Town of Erie, Colorado Development Referral

Project: Wise Farms

Description: Rezoning, Planned Unit Development Overlay & Preliminary Plat

Subject: Wise Farms, Rezoning, Planned Unit Development Overlay & Preliminary Plat

EXHIBIT A SALE AREA
 +27,937,355.2 S.F.
 +642.73 AC. ± S.F.
 2-15-2008

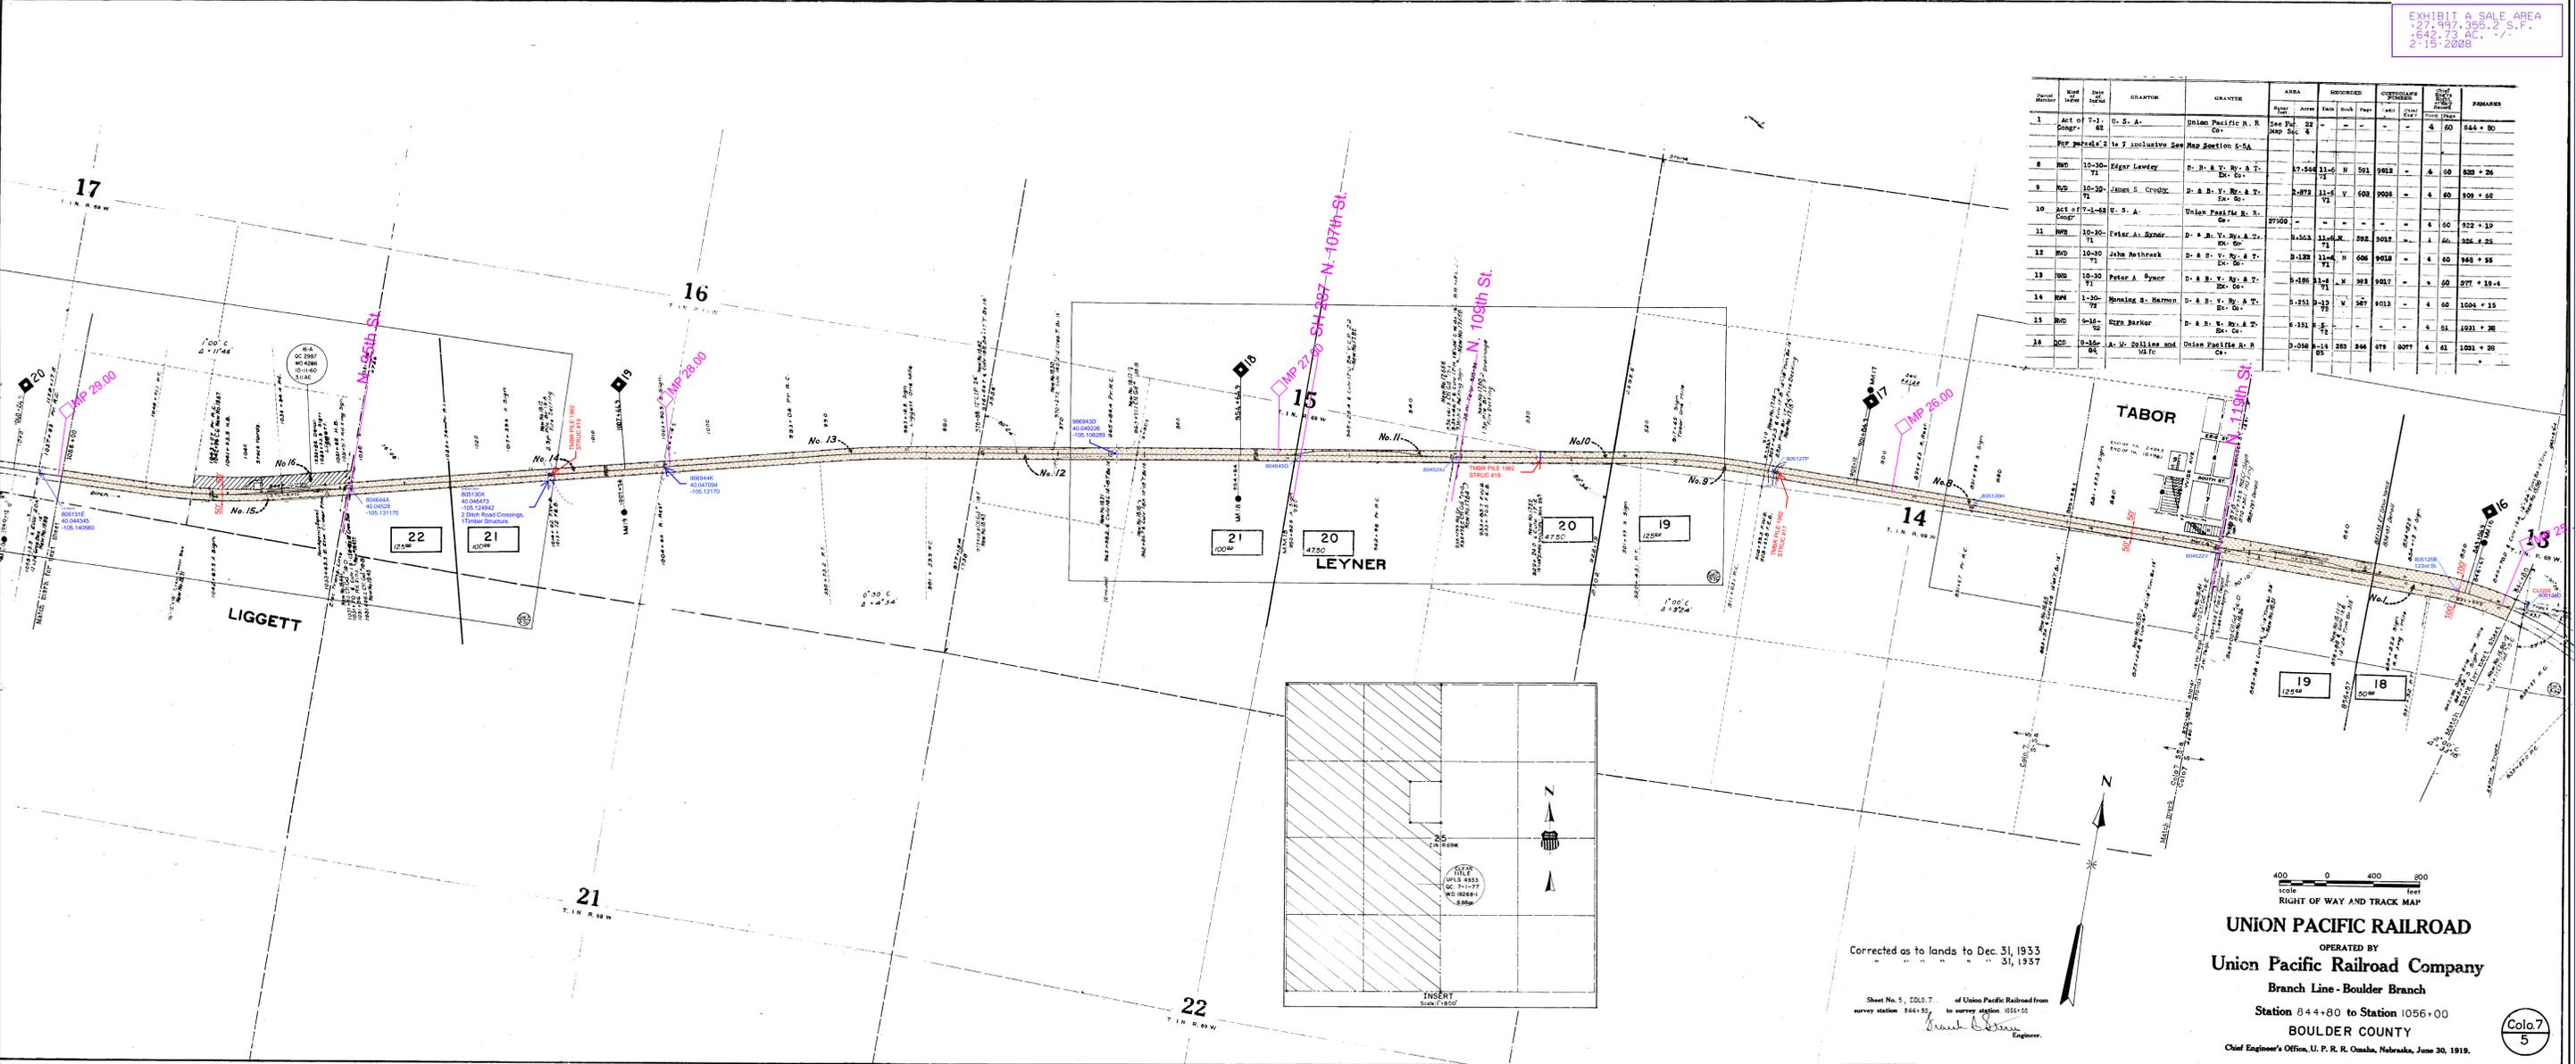
1. Please see attached exhibit for what we believe is RTD's Right-of-way (ROW) through this area, which we call Boulder Industrial Lead (BIL). The Boulder County Assessor's Office web site indicates that the RTD BIL ROW is not continuous through the development area. A land locked parcel of the BIL ROW is recorded as owned by the City of Erie. The Land Title Survey Sheets 22,23, and 24 of the Preliminary Development refer to the subject parcel as Area of Concern #4. Please provide documentation as to why you believe this area is owned by the City of Erie.
2. RTD does not grant easements. Please contact Susan Altes, RTD's Senior Manager of Real Property Susan.Altres@RTD-Denver.com 303-299-2440.
